MELBOURNE METRO EES INQUIRY

*PROPOSED MELBOURNE METRO
DOMAIN STATION
ASSESSMENT OF AIR QUALITY
ISSUES*

Prepared for Owners Corporation 348427V of 400
St Kilda Road, Melbourne (“The Botanica”)

12 August 2016

Fig 1. Domain Station precinct (based on Figure 6-9 of the EES) showing extent of construction activities and the Botanica site (in red)

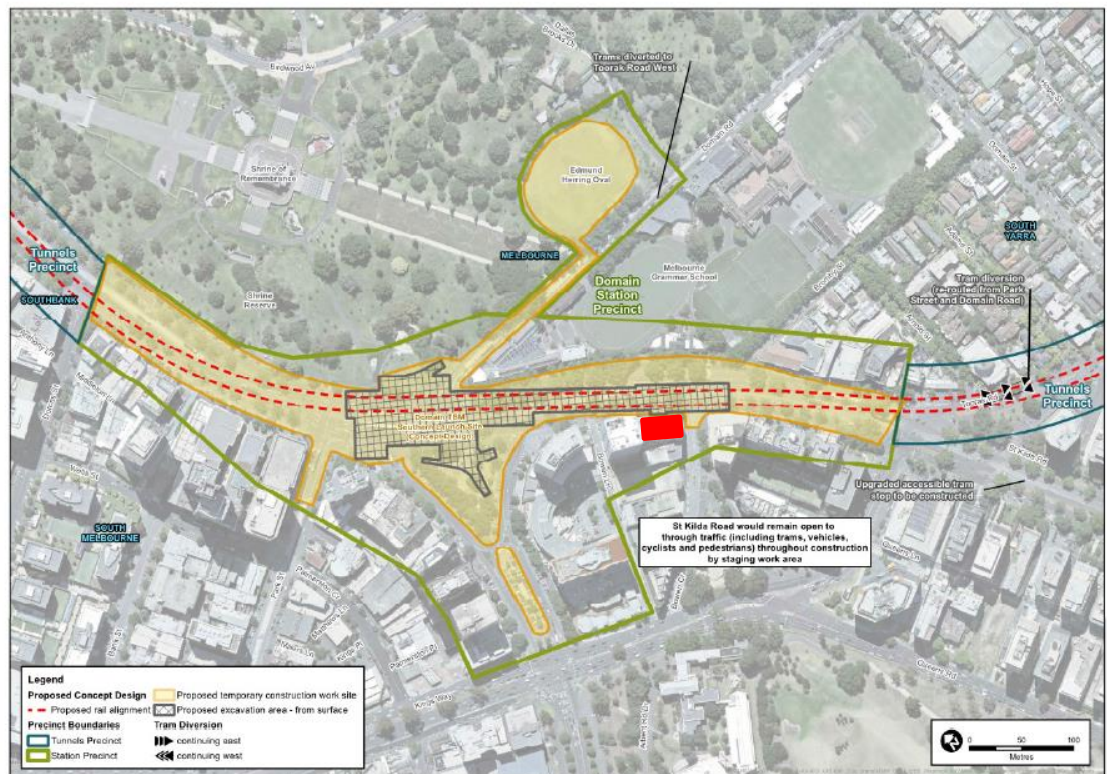
The Botanica apartments will be particularly sensitive to an increase in local dust levels, because I understand that all of the apartments facing St Kilda Road and Bowen Crescent (and most of the others) have doors opening onto balconies, openable windows and most have individual “split” air conditioning systems (the only way to introduce fresh air into the apartments is by opening external doors and/or windows).

Figure 7-8: Conceptual site model for the tunnels area between CBD South and Domain stations

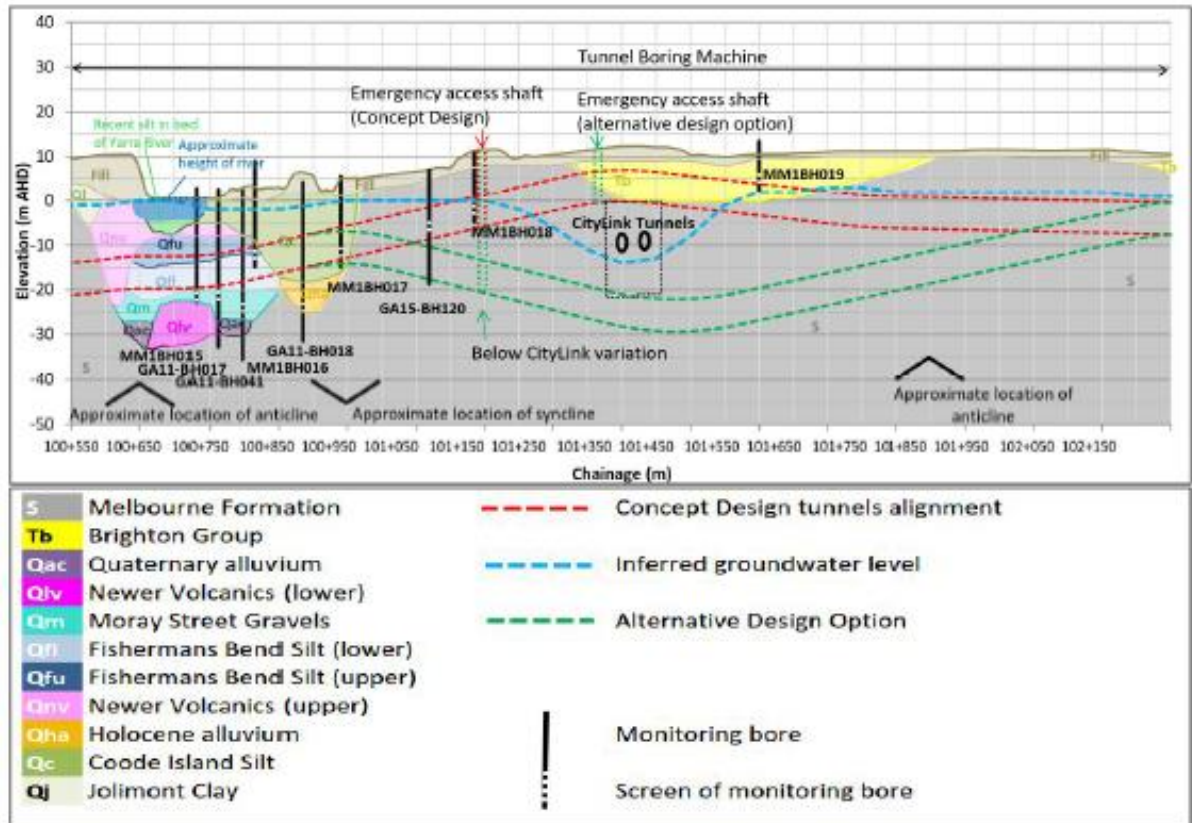
Figure 7-8 indicates that these tunnels will be bored predominantly through the Melbourne Formation. The "Concept Design" tunnels will be above the watertable in the vicinity of the CityLink tunnels (which result in a drawdown of the watertable). In contrast, the "Alternative Design Option" alignment, which passes under the CityLink tunnels, is below the watertable.

Figure 7-10: Conceptual site model for the tunnels area between Domain station and the eastern portal

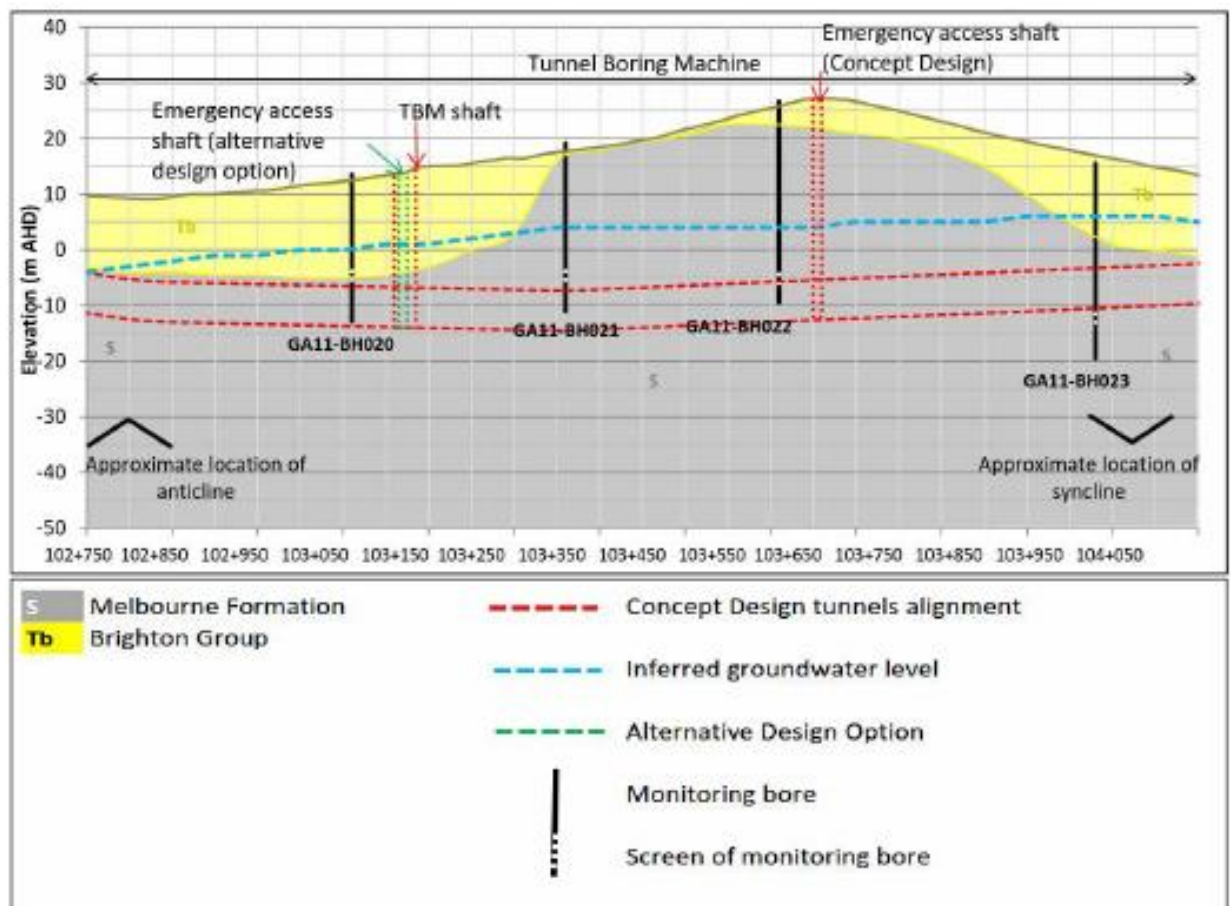
Figure 7-10 indicates that these tunnels will be bored entirely through the Melbourne Formation and below the watertable.

Figure 7-10 indicates that the (unsaturated) Brighton Group overlies the Melbourne Formation in the vicinity of Domain Station and that the (approximately 19 m deep) excavation for the station will penetrate about 10 m into the Melbourne Formation. There is a significant drawdown of the water table in this location (as a result of infiltration of groundwater into the South Yarra Main Sewer), which suggests that the majority of the Melbourne Formation to be excavated to form the “station box” will be above the water table.
